BG96 R1.0 & BG96 R1.2

Differences Statement

LTE Module Series

Ref: FCC Class II Permissive change for FCC ID: XMR201707BG96
Original Grant Date: 07/20/2017
Class II Grant Date: 09/12/2017
Applicant: Quectel Wireless Solutions Co., Ltd

Figure 1: Schematic Designs of BG96 R1.1 and R1.2

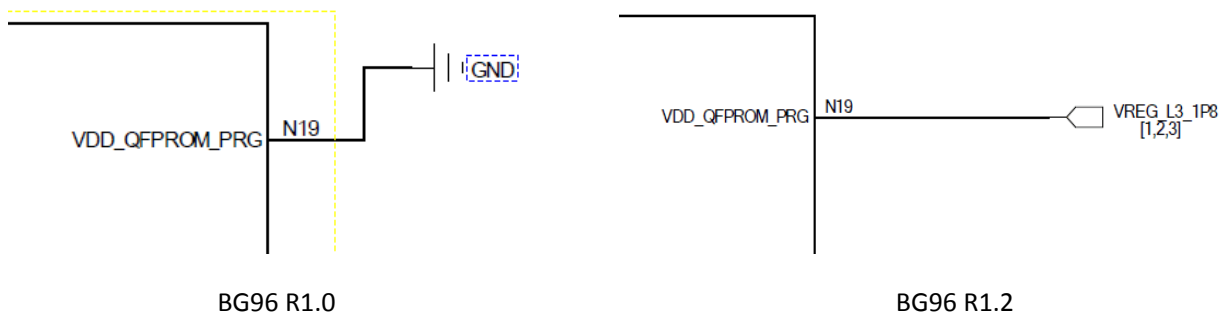
The VDD_QFPROM_PRG (N19) pin of baseband chip is for secure boot function. In BG96 R1.1, this pin is connected to ground directly, which means secure boot function is disabled.

According to Qualcomm's suggestion and our customers' requirements, the VDD_QFPROM_PRG pin is connected to VREG_L3_1P8(1.8V) in BG96 R1.2 so as to enable secure boot function.

Figure 2: PCB Designs of BG96 R1.0 and R1.2

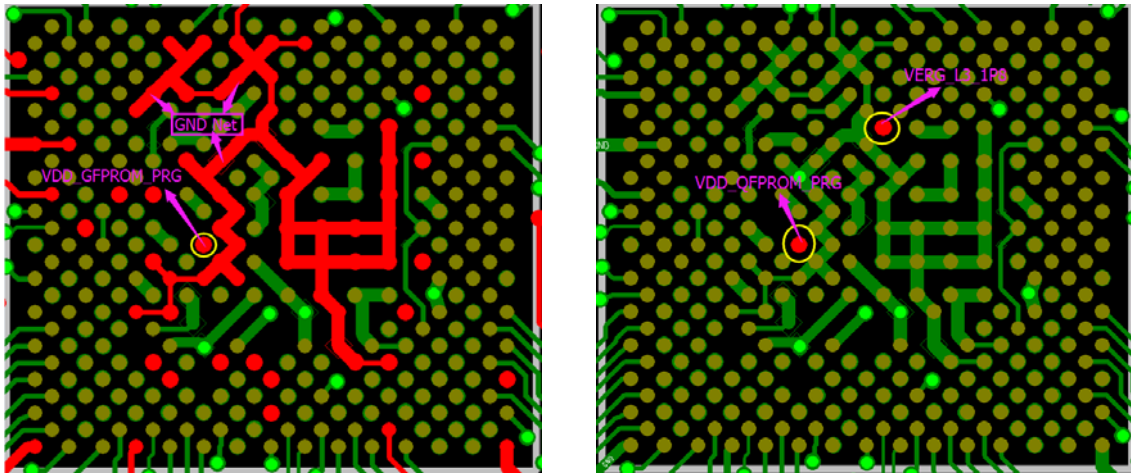
Based on BG96 R1.0, BG96 R1.2 has enabled VDD_QFPROM_PRG hardware interface, which is connected to ground directly in BG96 R1.1, so as to support secure boot feature.
